Product/Process Change Notice (PCN)

PCN #: PCN_WE-STAR-
TEC_20151207_74271131(S)_Capacity Increase
Product Affected: 74271131, 74271131S, 742711319

PCN Date: 07.12.2015
Effective Date: 07.03.2016

Already established production line of plastic housing:

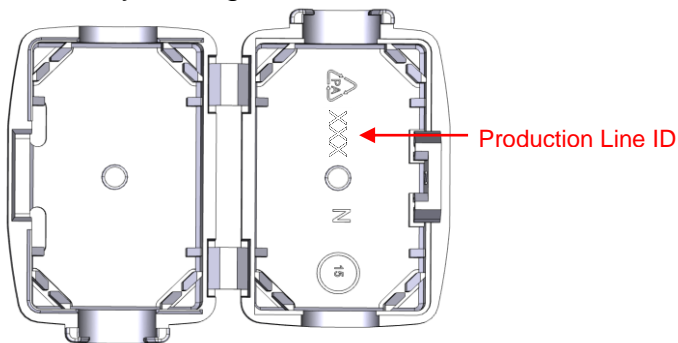
1. Neither electrical nor mechanical properties of the part will be changed.
2. The production lines can be identified by the three digits inside the plastic housing.

Digits: 128

Country of Origin: Germany

Additional production line of plastic housing:

Digits: 312

Country of Origin: Austria
